FORD E4OD REVERSE CLUTCH LIP SEALS FOR 1996 MODELS

CHANGE: Beginning at the Start Of Production for all 1996 models equipped with the E40D transmission, Ford Motor Company installed "Lip" seals on the reverse clutch piston and addad a cushion (W) plate to the reverse clutch pack.

Figure 1
AUTOMATIC TRANSMISSION SERVICE GROUP

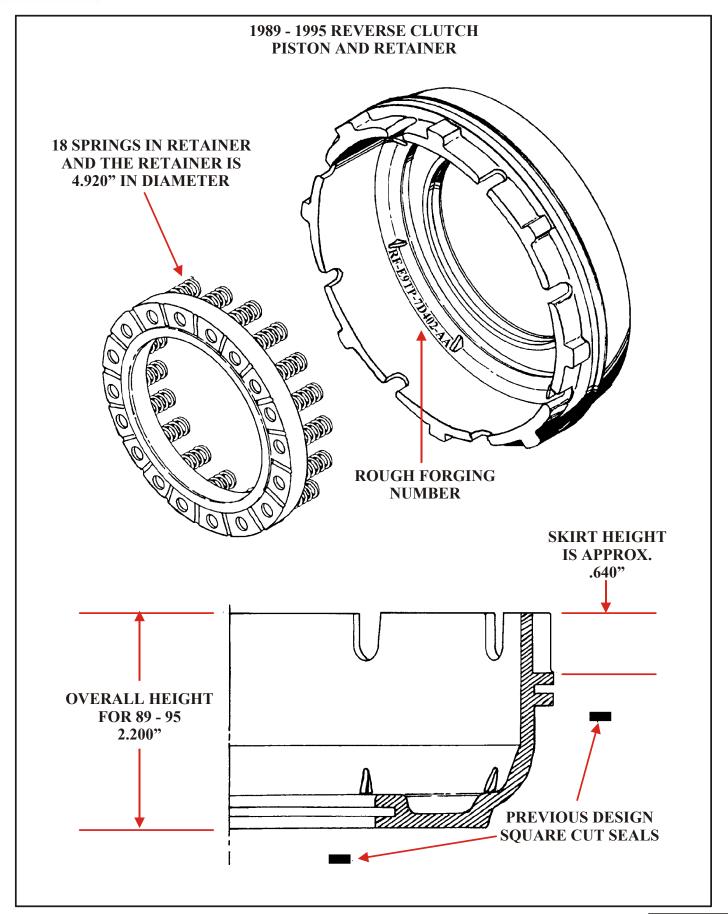
- (1) REVERSE CLUTCH PISTON SEALS- Change from the previous "Square" cut seals to the new design "Lip" seals, for increased sealing ability. Refer to Figures 1, 2 and 3. (2) REVERSE PISTON Seal grooves in the piston are machined differently to accommodate the new design lip seals. The reverse piston skirt is also .140" shorter than the previous piston, to accommodate the added cushion (Wave) plate in the reverse clutch pack. This will obviously also afect the overall height of the piston. Refer to Figures 1, 2 and 3. The pistons can be identified by the "Rough Forging" number, as shown in Figures 1 and 2. Rough Forging Number RF-E9TP-7D402-AA = 89-95 Model (Square Cut Seals) Rough Forging Number RF-F6TP-7D402-AA = 1996 Model (Lip Seals)

- (3) REVERSE PISTON SPRING RETAINER New design level spring retainer has 23 return springs in the retainer, instead of the previous 18 return springs. The new design level 23 spring retainer is also approximately 1/4" larger in diameter, 5.200" as opposed to the previous 4.920", which will allow a better cushion. Refer to Figures 1 and 2.
